**AGENDA  
TOWN OF PITTSFORD  
PLANNING BOARD  
OCTOBER 27, 2025**

**TOWN OF PITTSFORD  
PLANNING BOARD  
SEQRA RESOLUTION  
834 Linden Ave (Universal Imports)  
Preliminary/Final Site Plan  
Tax Parcel #138.15-1-7**

**TOWN OF PITTSFORD  
PLANNING BOARD  
RESOLUTION  
Clover Street Development Corp.  
Coventry Ridge Subdivision – Section 3  
Final Subdivision  
Tax Parcel #177.04-03-5-47**

**Re: Coventry Ridge, Section 3 Plan Review Comments  
Final Site Plan  
MRB Group Project No. 1660.12001.000**

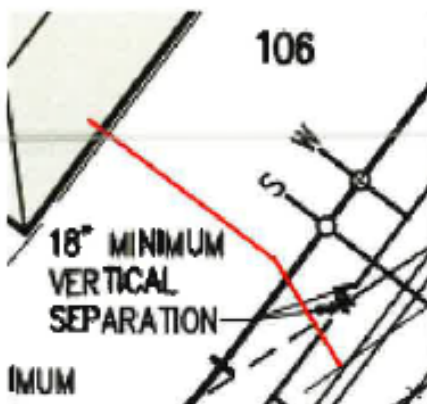
1. The sanitary lateral for lot number 98 should be realigned to connect to the existing sewer main aligned down the side lot, as opposed to the current planned connection. The image below further details this change:

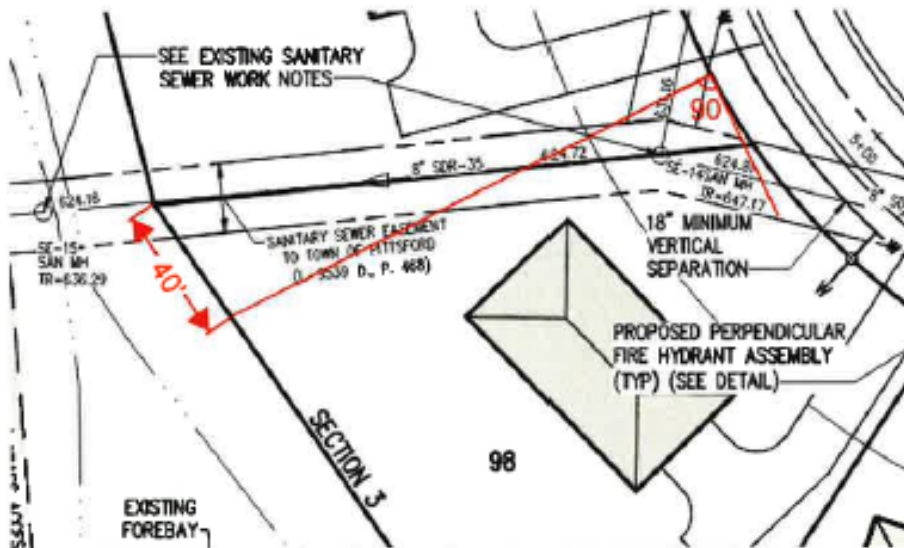
2. The sanitary lateral for lot 106 should be realigned to connect to the existing sewer main at a 90-degree angle. The image below further details this change:

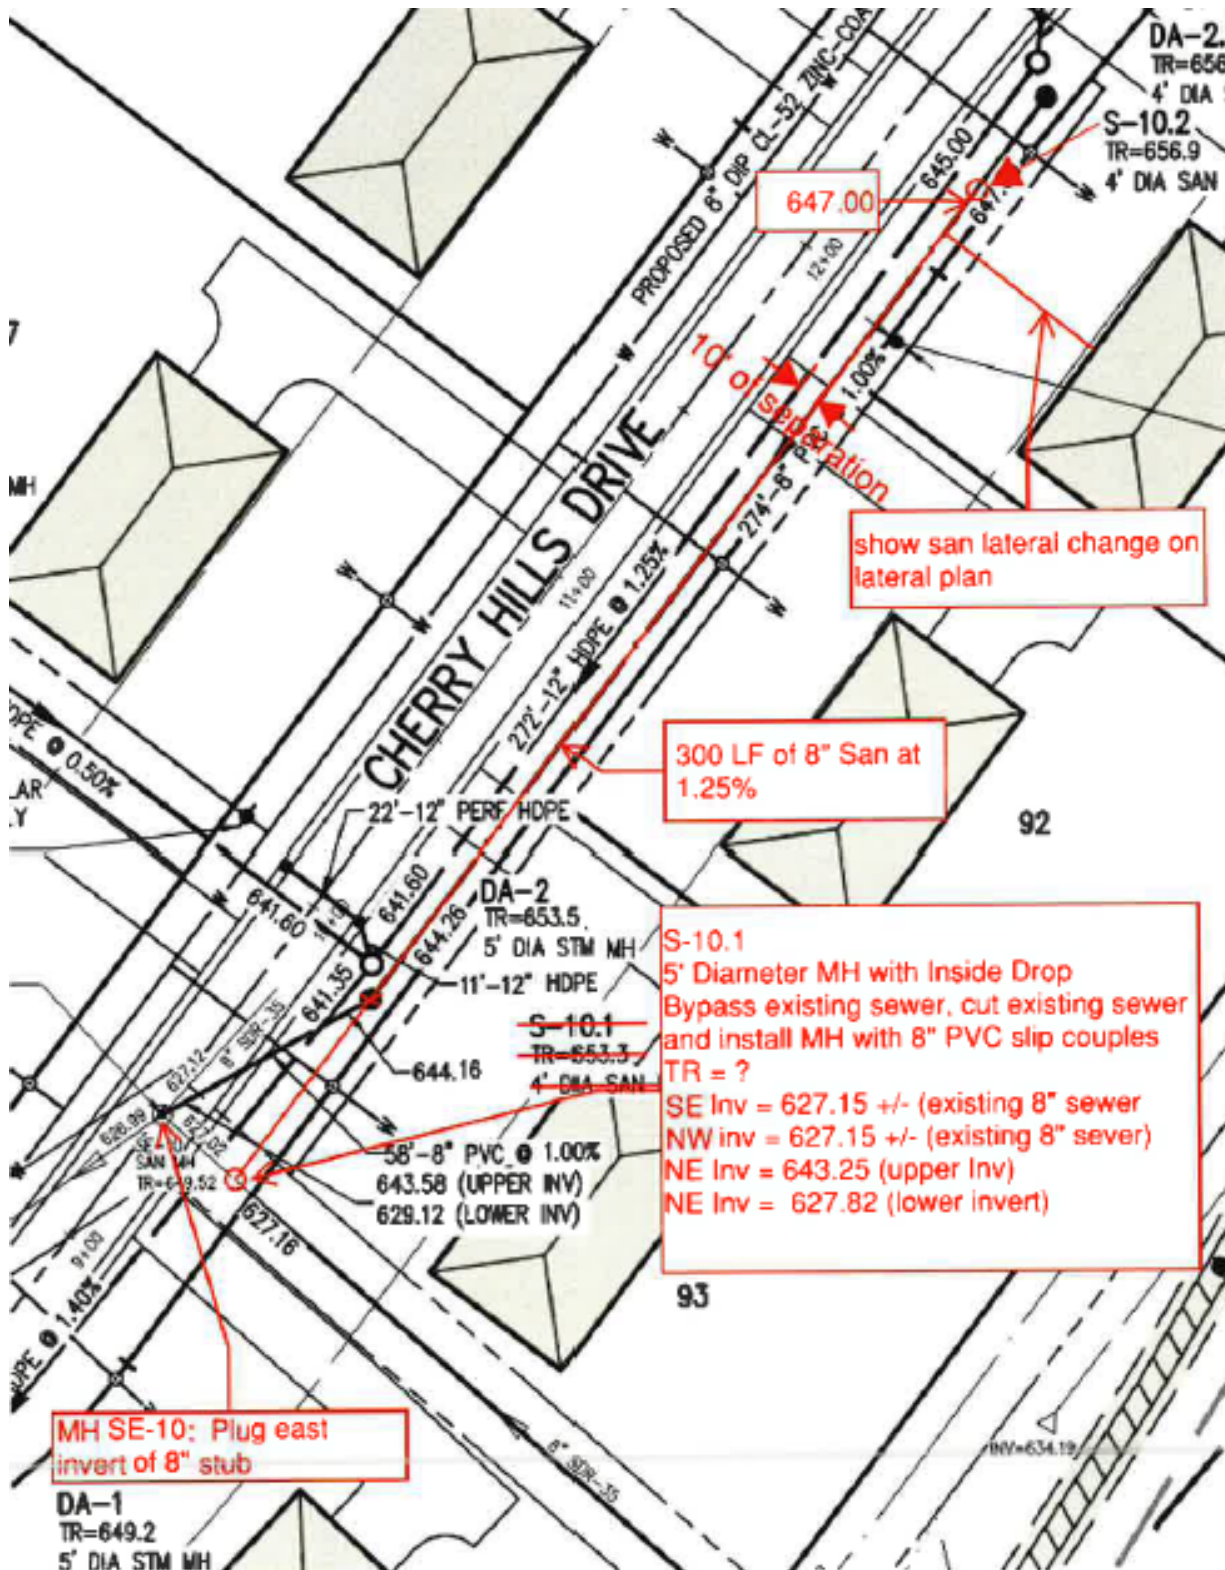
4. The current plan proposes an approximate 15' long, outside drop connection to the existing 4' diameter MH SE-10. The existing MH is approximately 24' deep, and there are concerns with a deep excavation along the side of this manhole, and the installation of an outside drop connection on the existing eastern MH stub, which is not aligned in the correct direction. Instead, it is recommended that the sanitary sewer aligned from MH S-10.2 be installed to a proposed 5' diameter inside drop manhole placed on the existing 8" sewer that is aligned between existing manholes SE-9 and SE-10. The sewer line from S-10.1 to S-10.2 will also need to be shifted southeasterly to provide a minimum 10 ft parallel offset from the storm sewer. Under this change, the existing sanitary sewer work note for MH SE-10 will need to be altered to simply describe the plugging of the existing eastern pipe stub, repair of the interior bench, along with the planned MH rim height change. A new note should be provided describing the bypass pumping and use of slip couplings associated with the installation of the new manhole S-10.1 on the existing sewer main. Also, under this change, the profiles will need to be edited accordingly, and the detail for an outside drop manhole can be removed from the drawings. The image below further details this change:

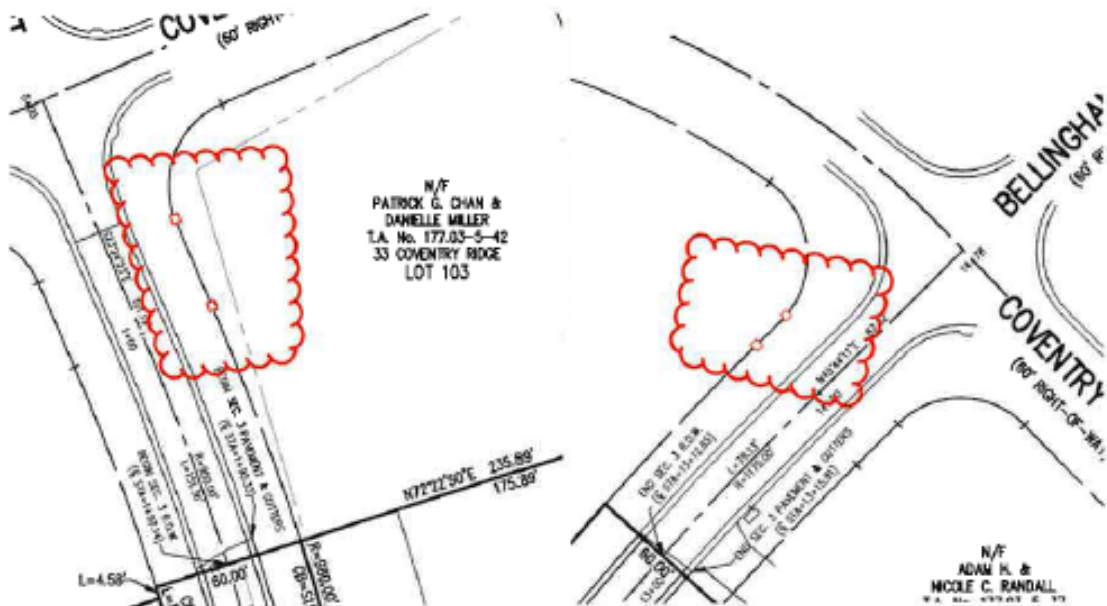
5. Please add four additional ROW monuments for Cherry Hill Drive at the locations shown below:
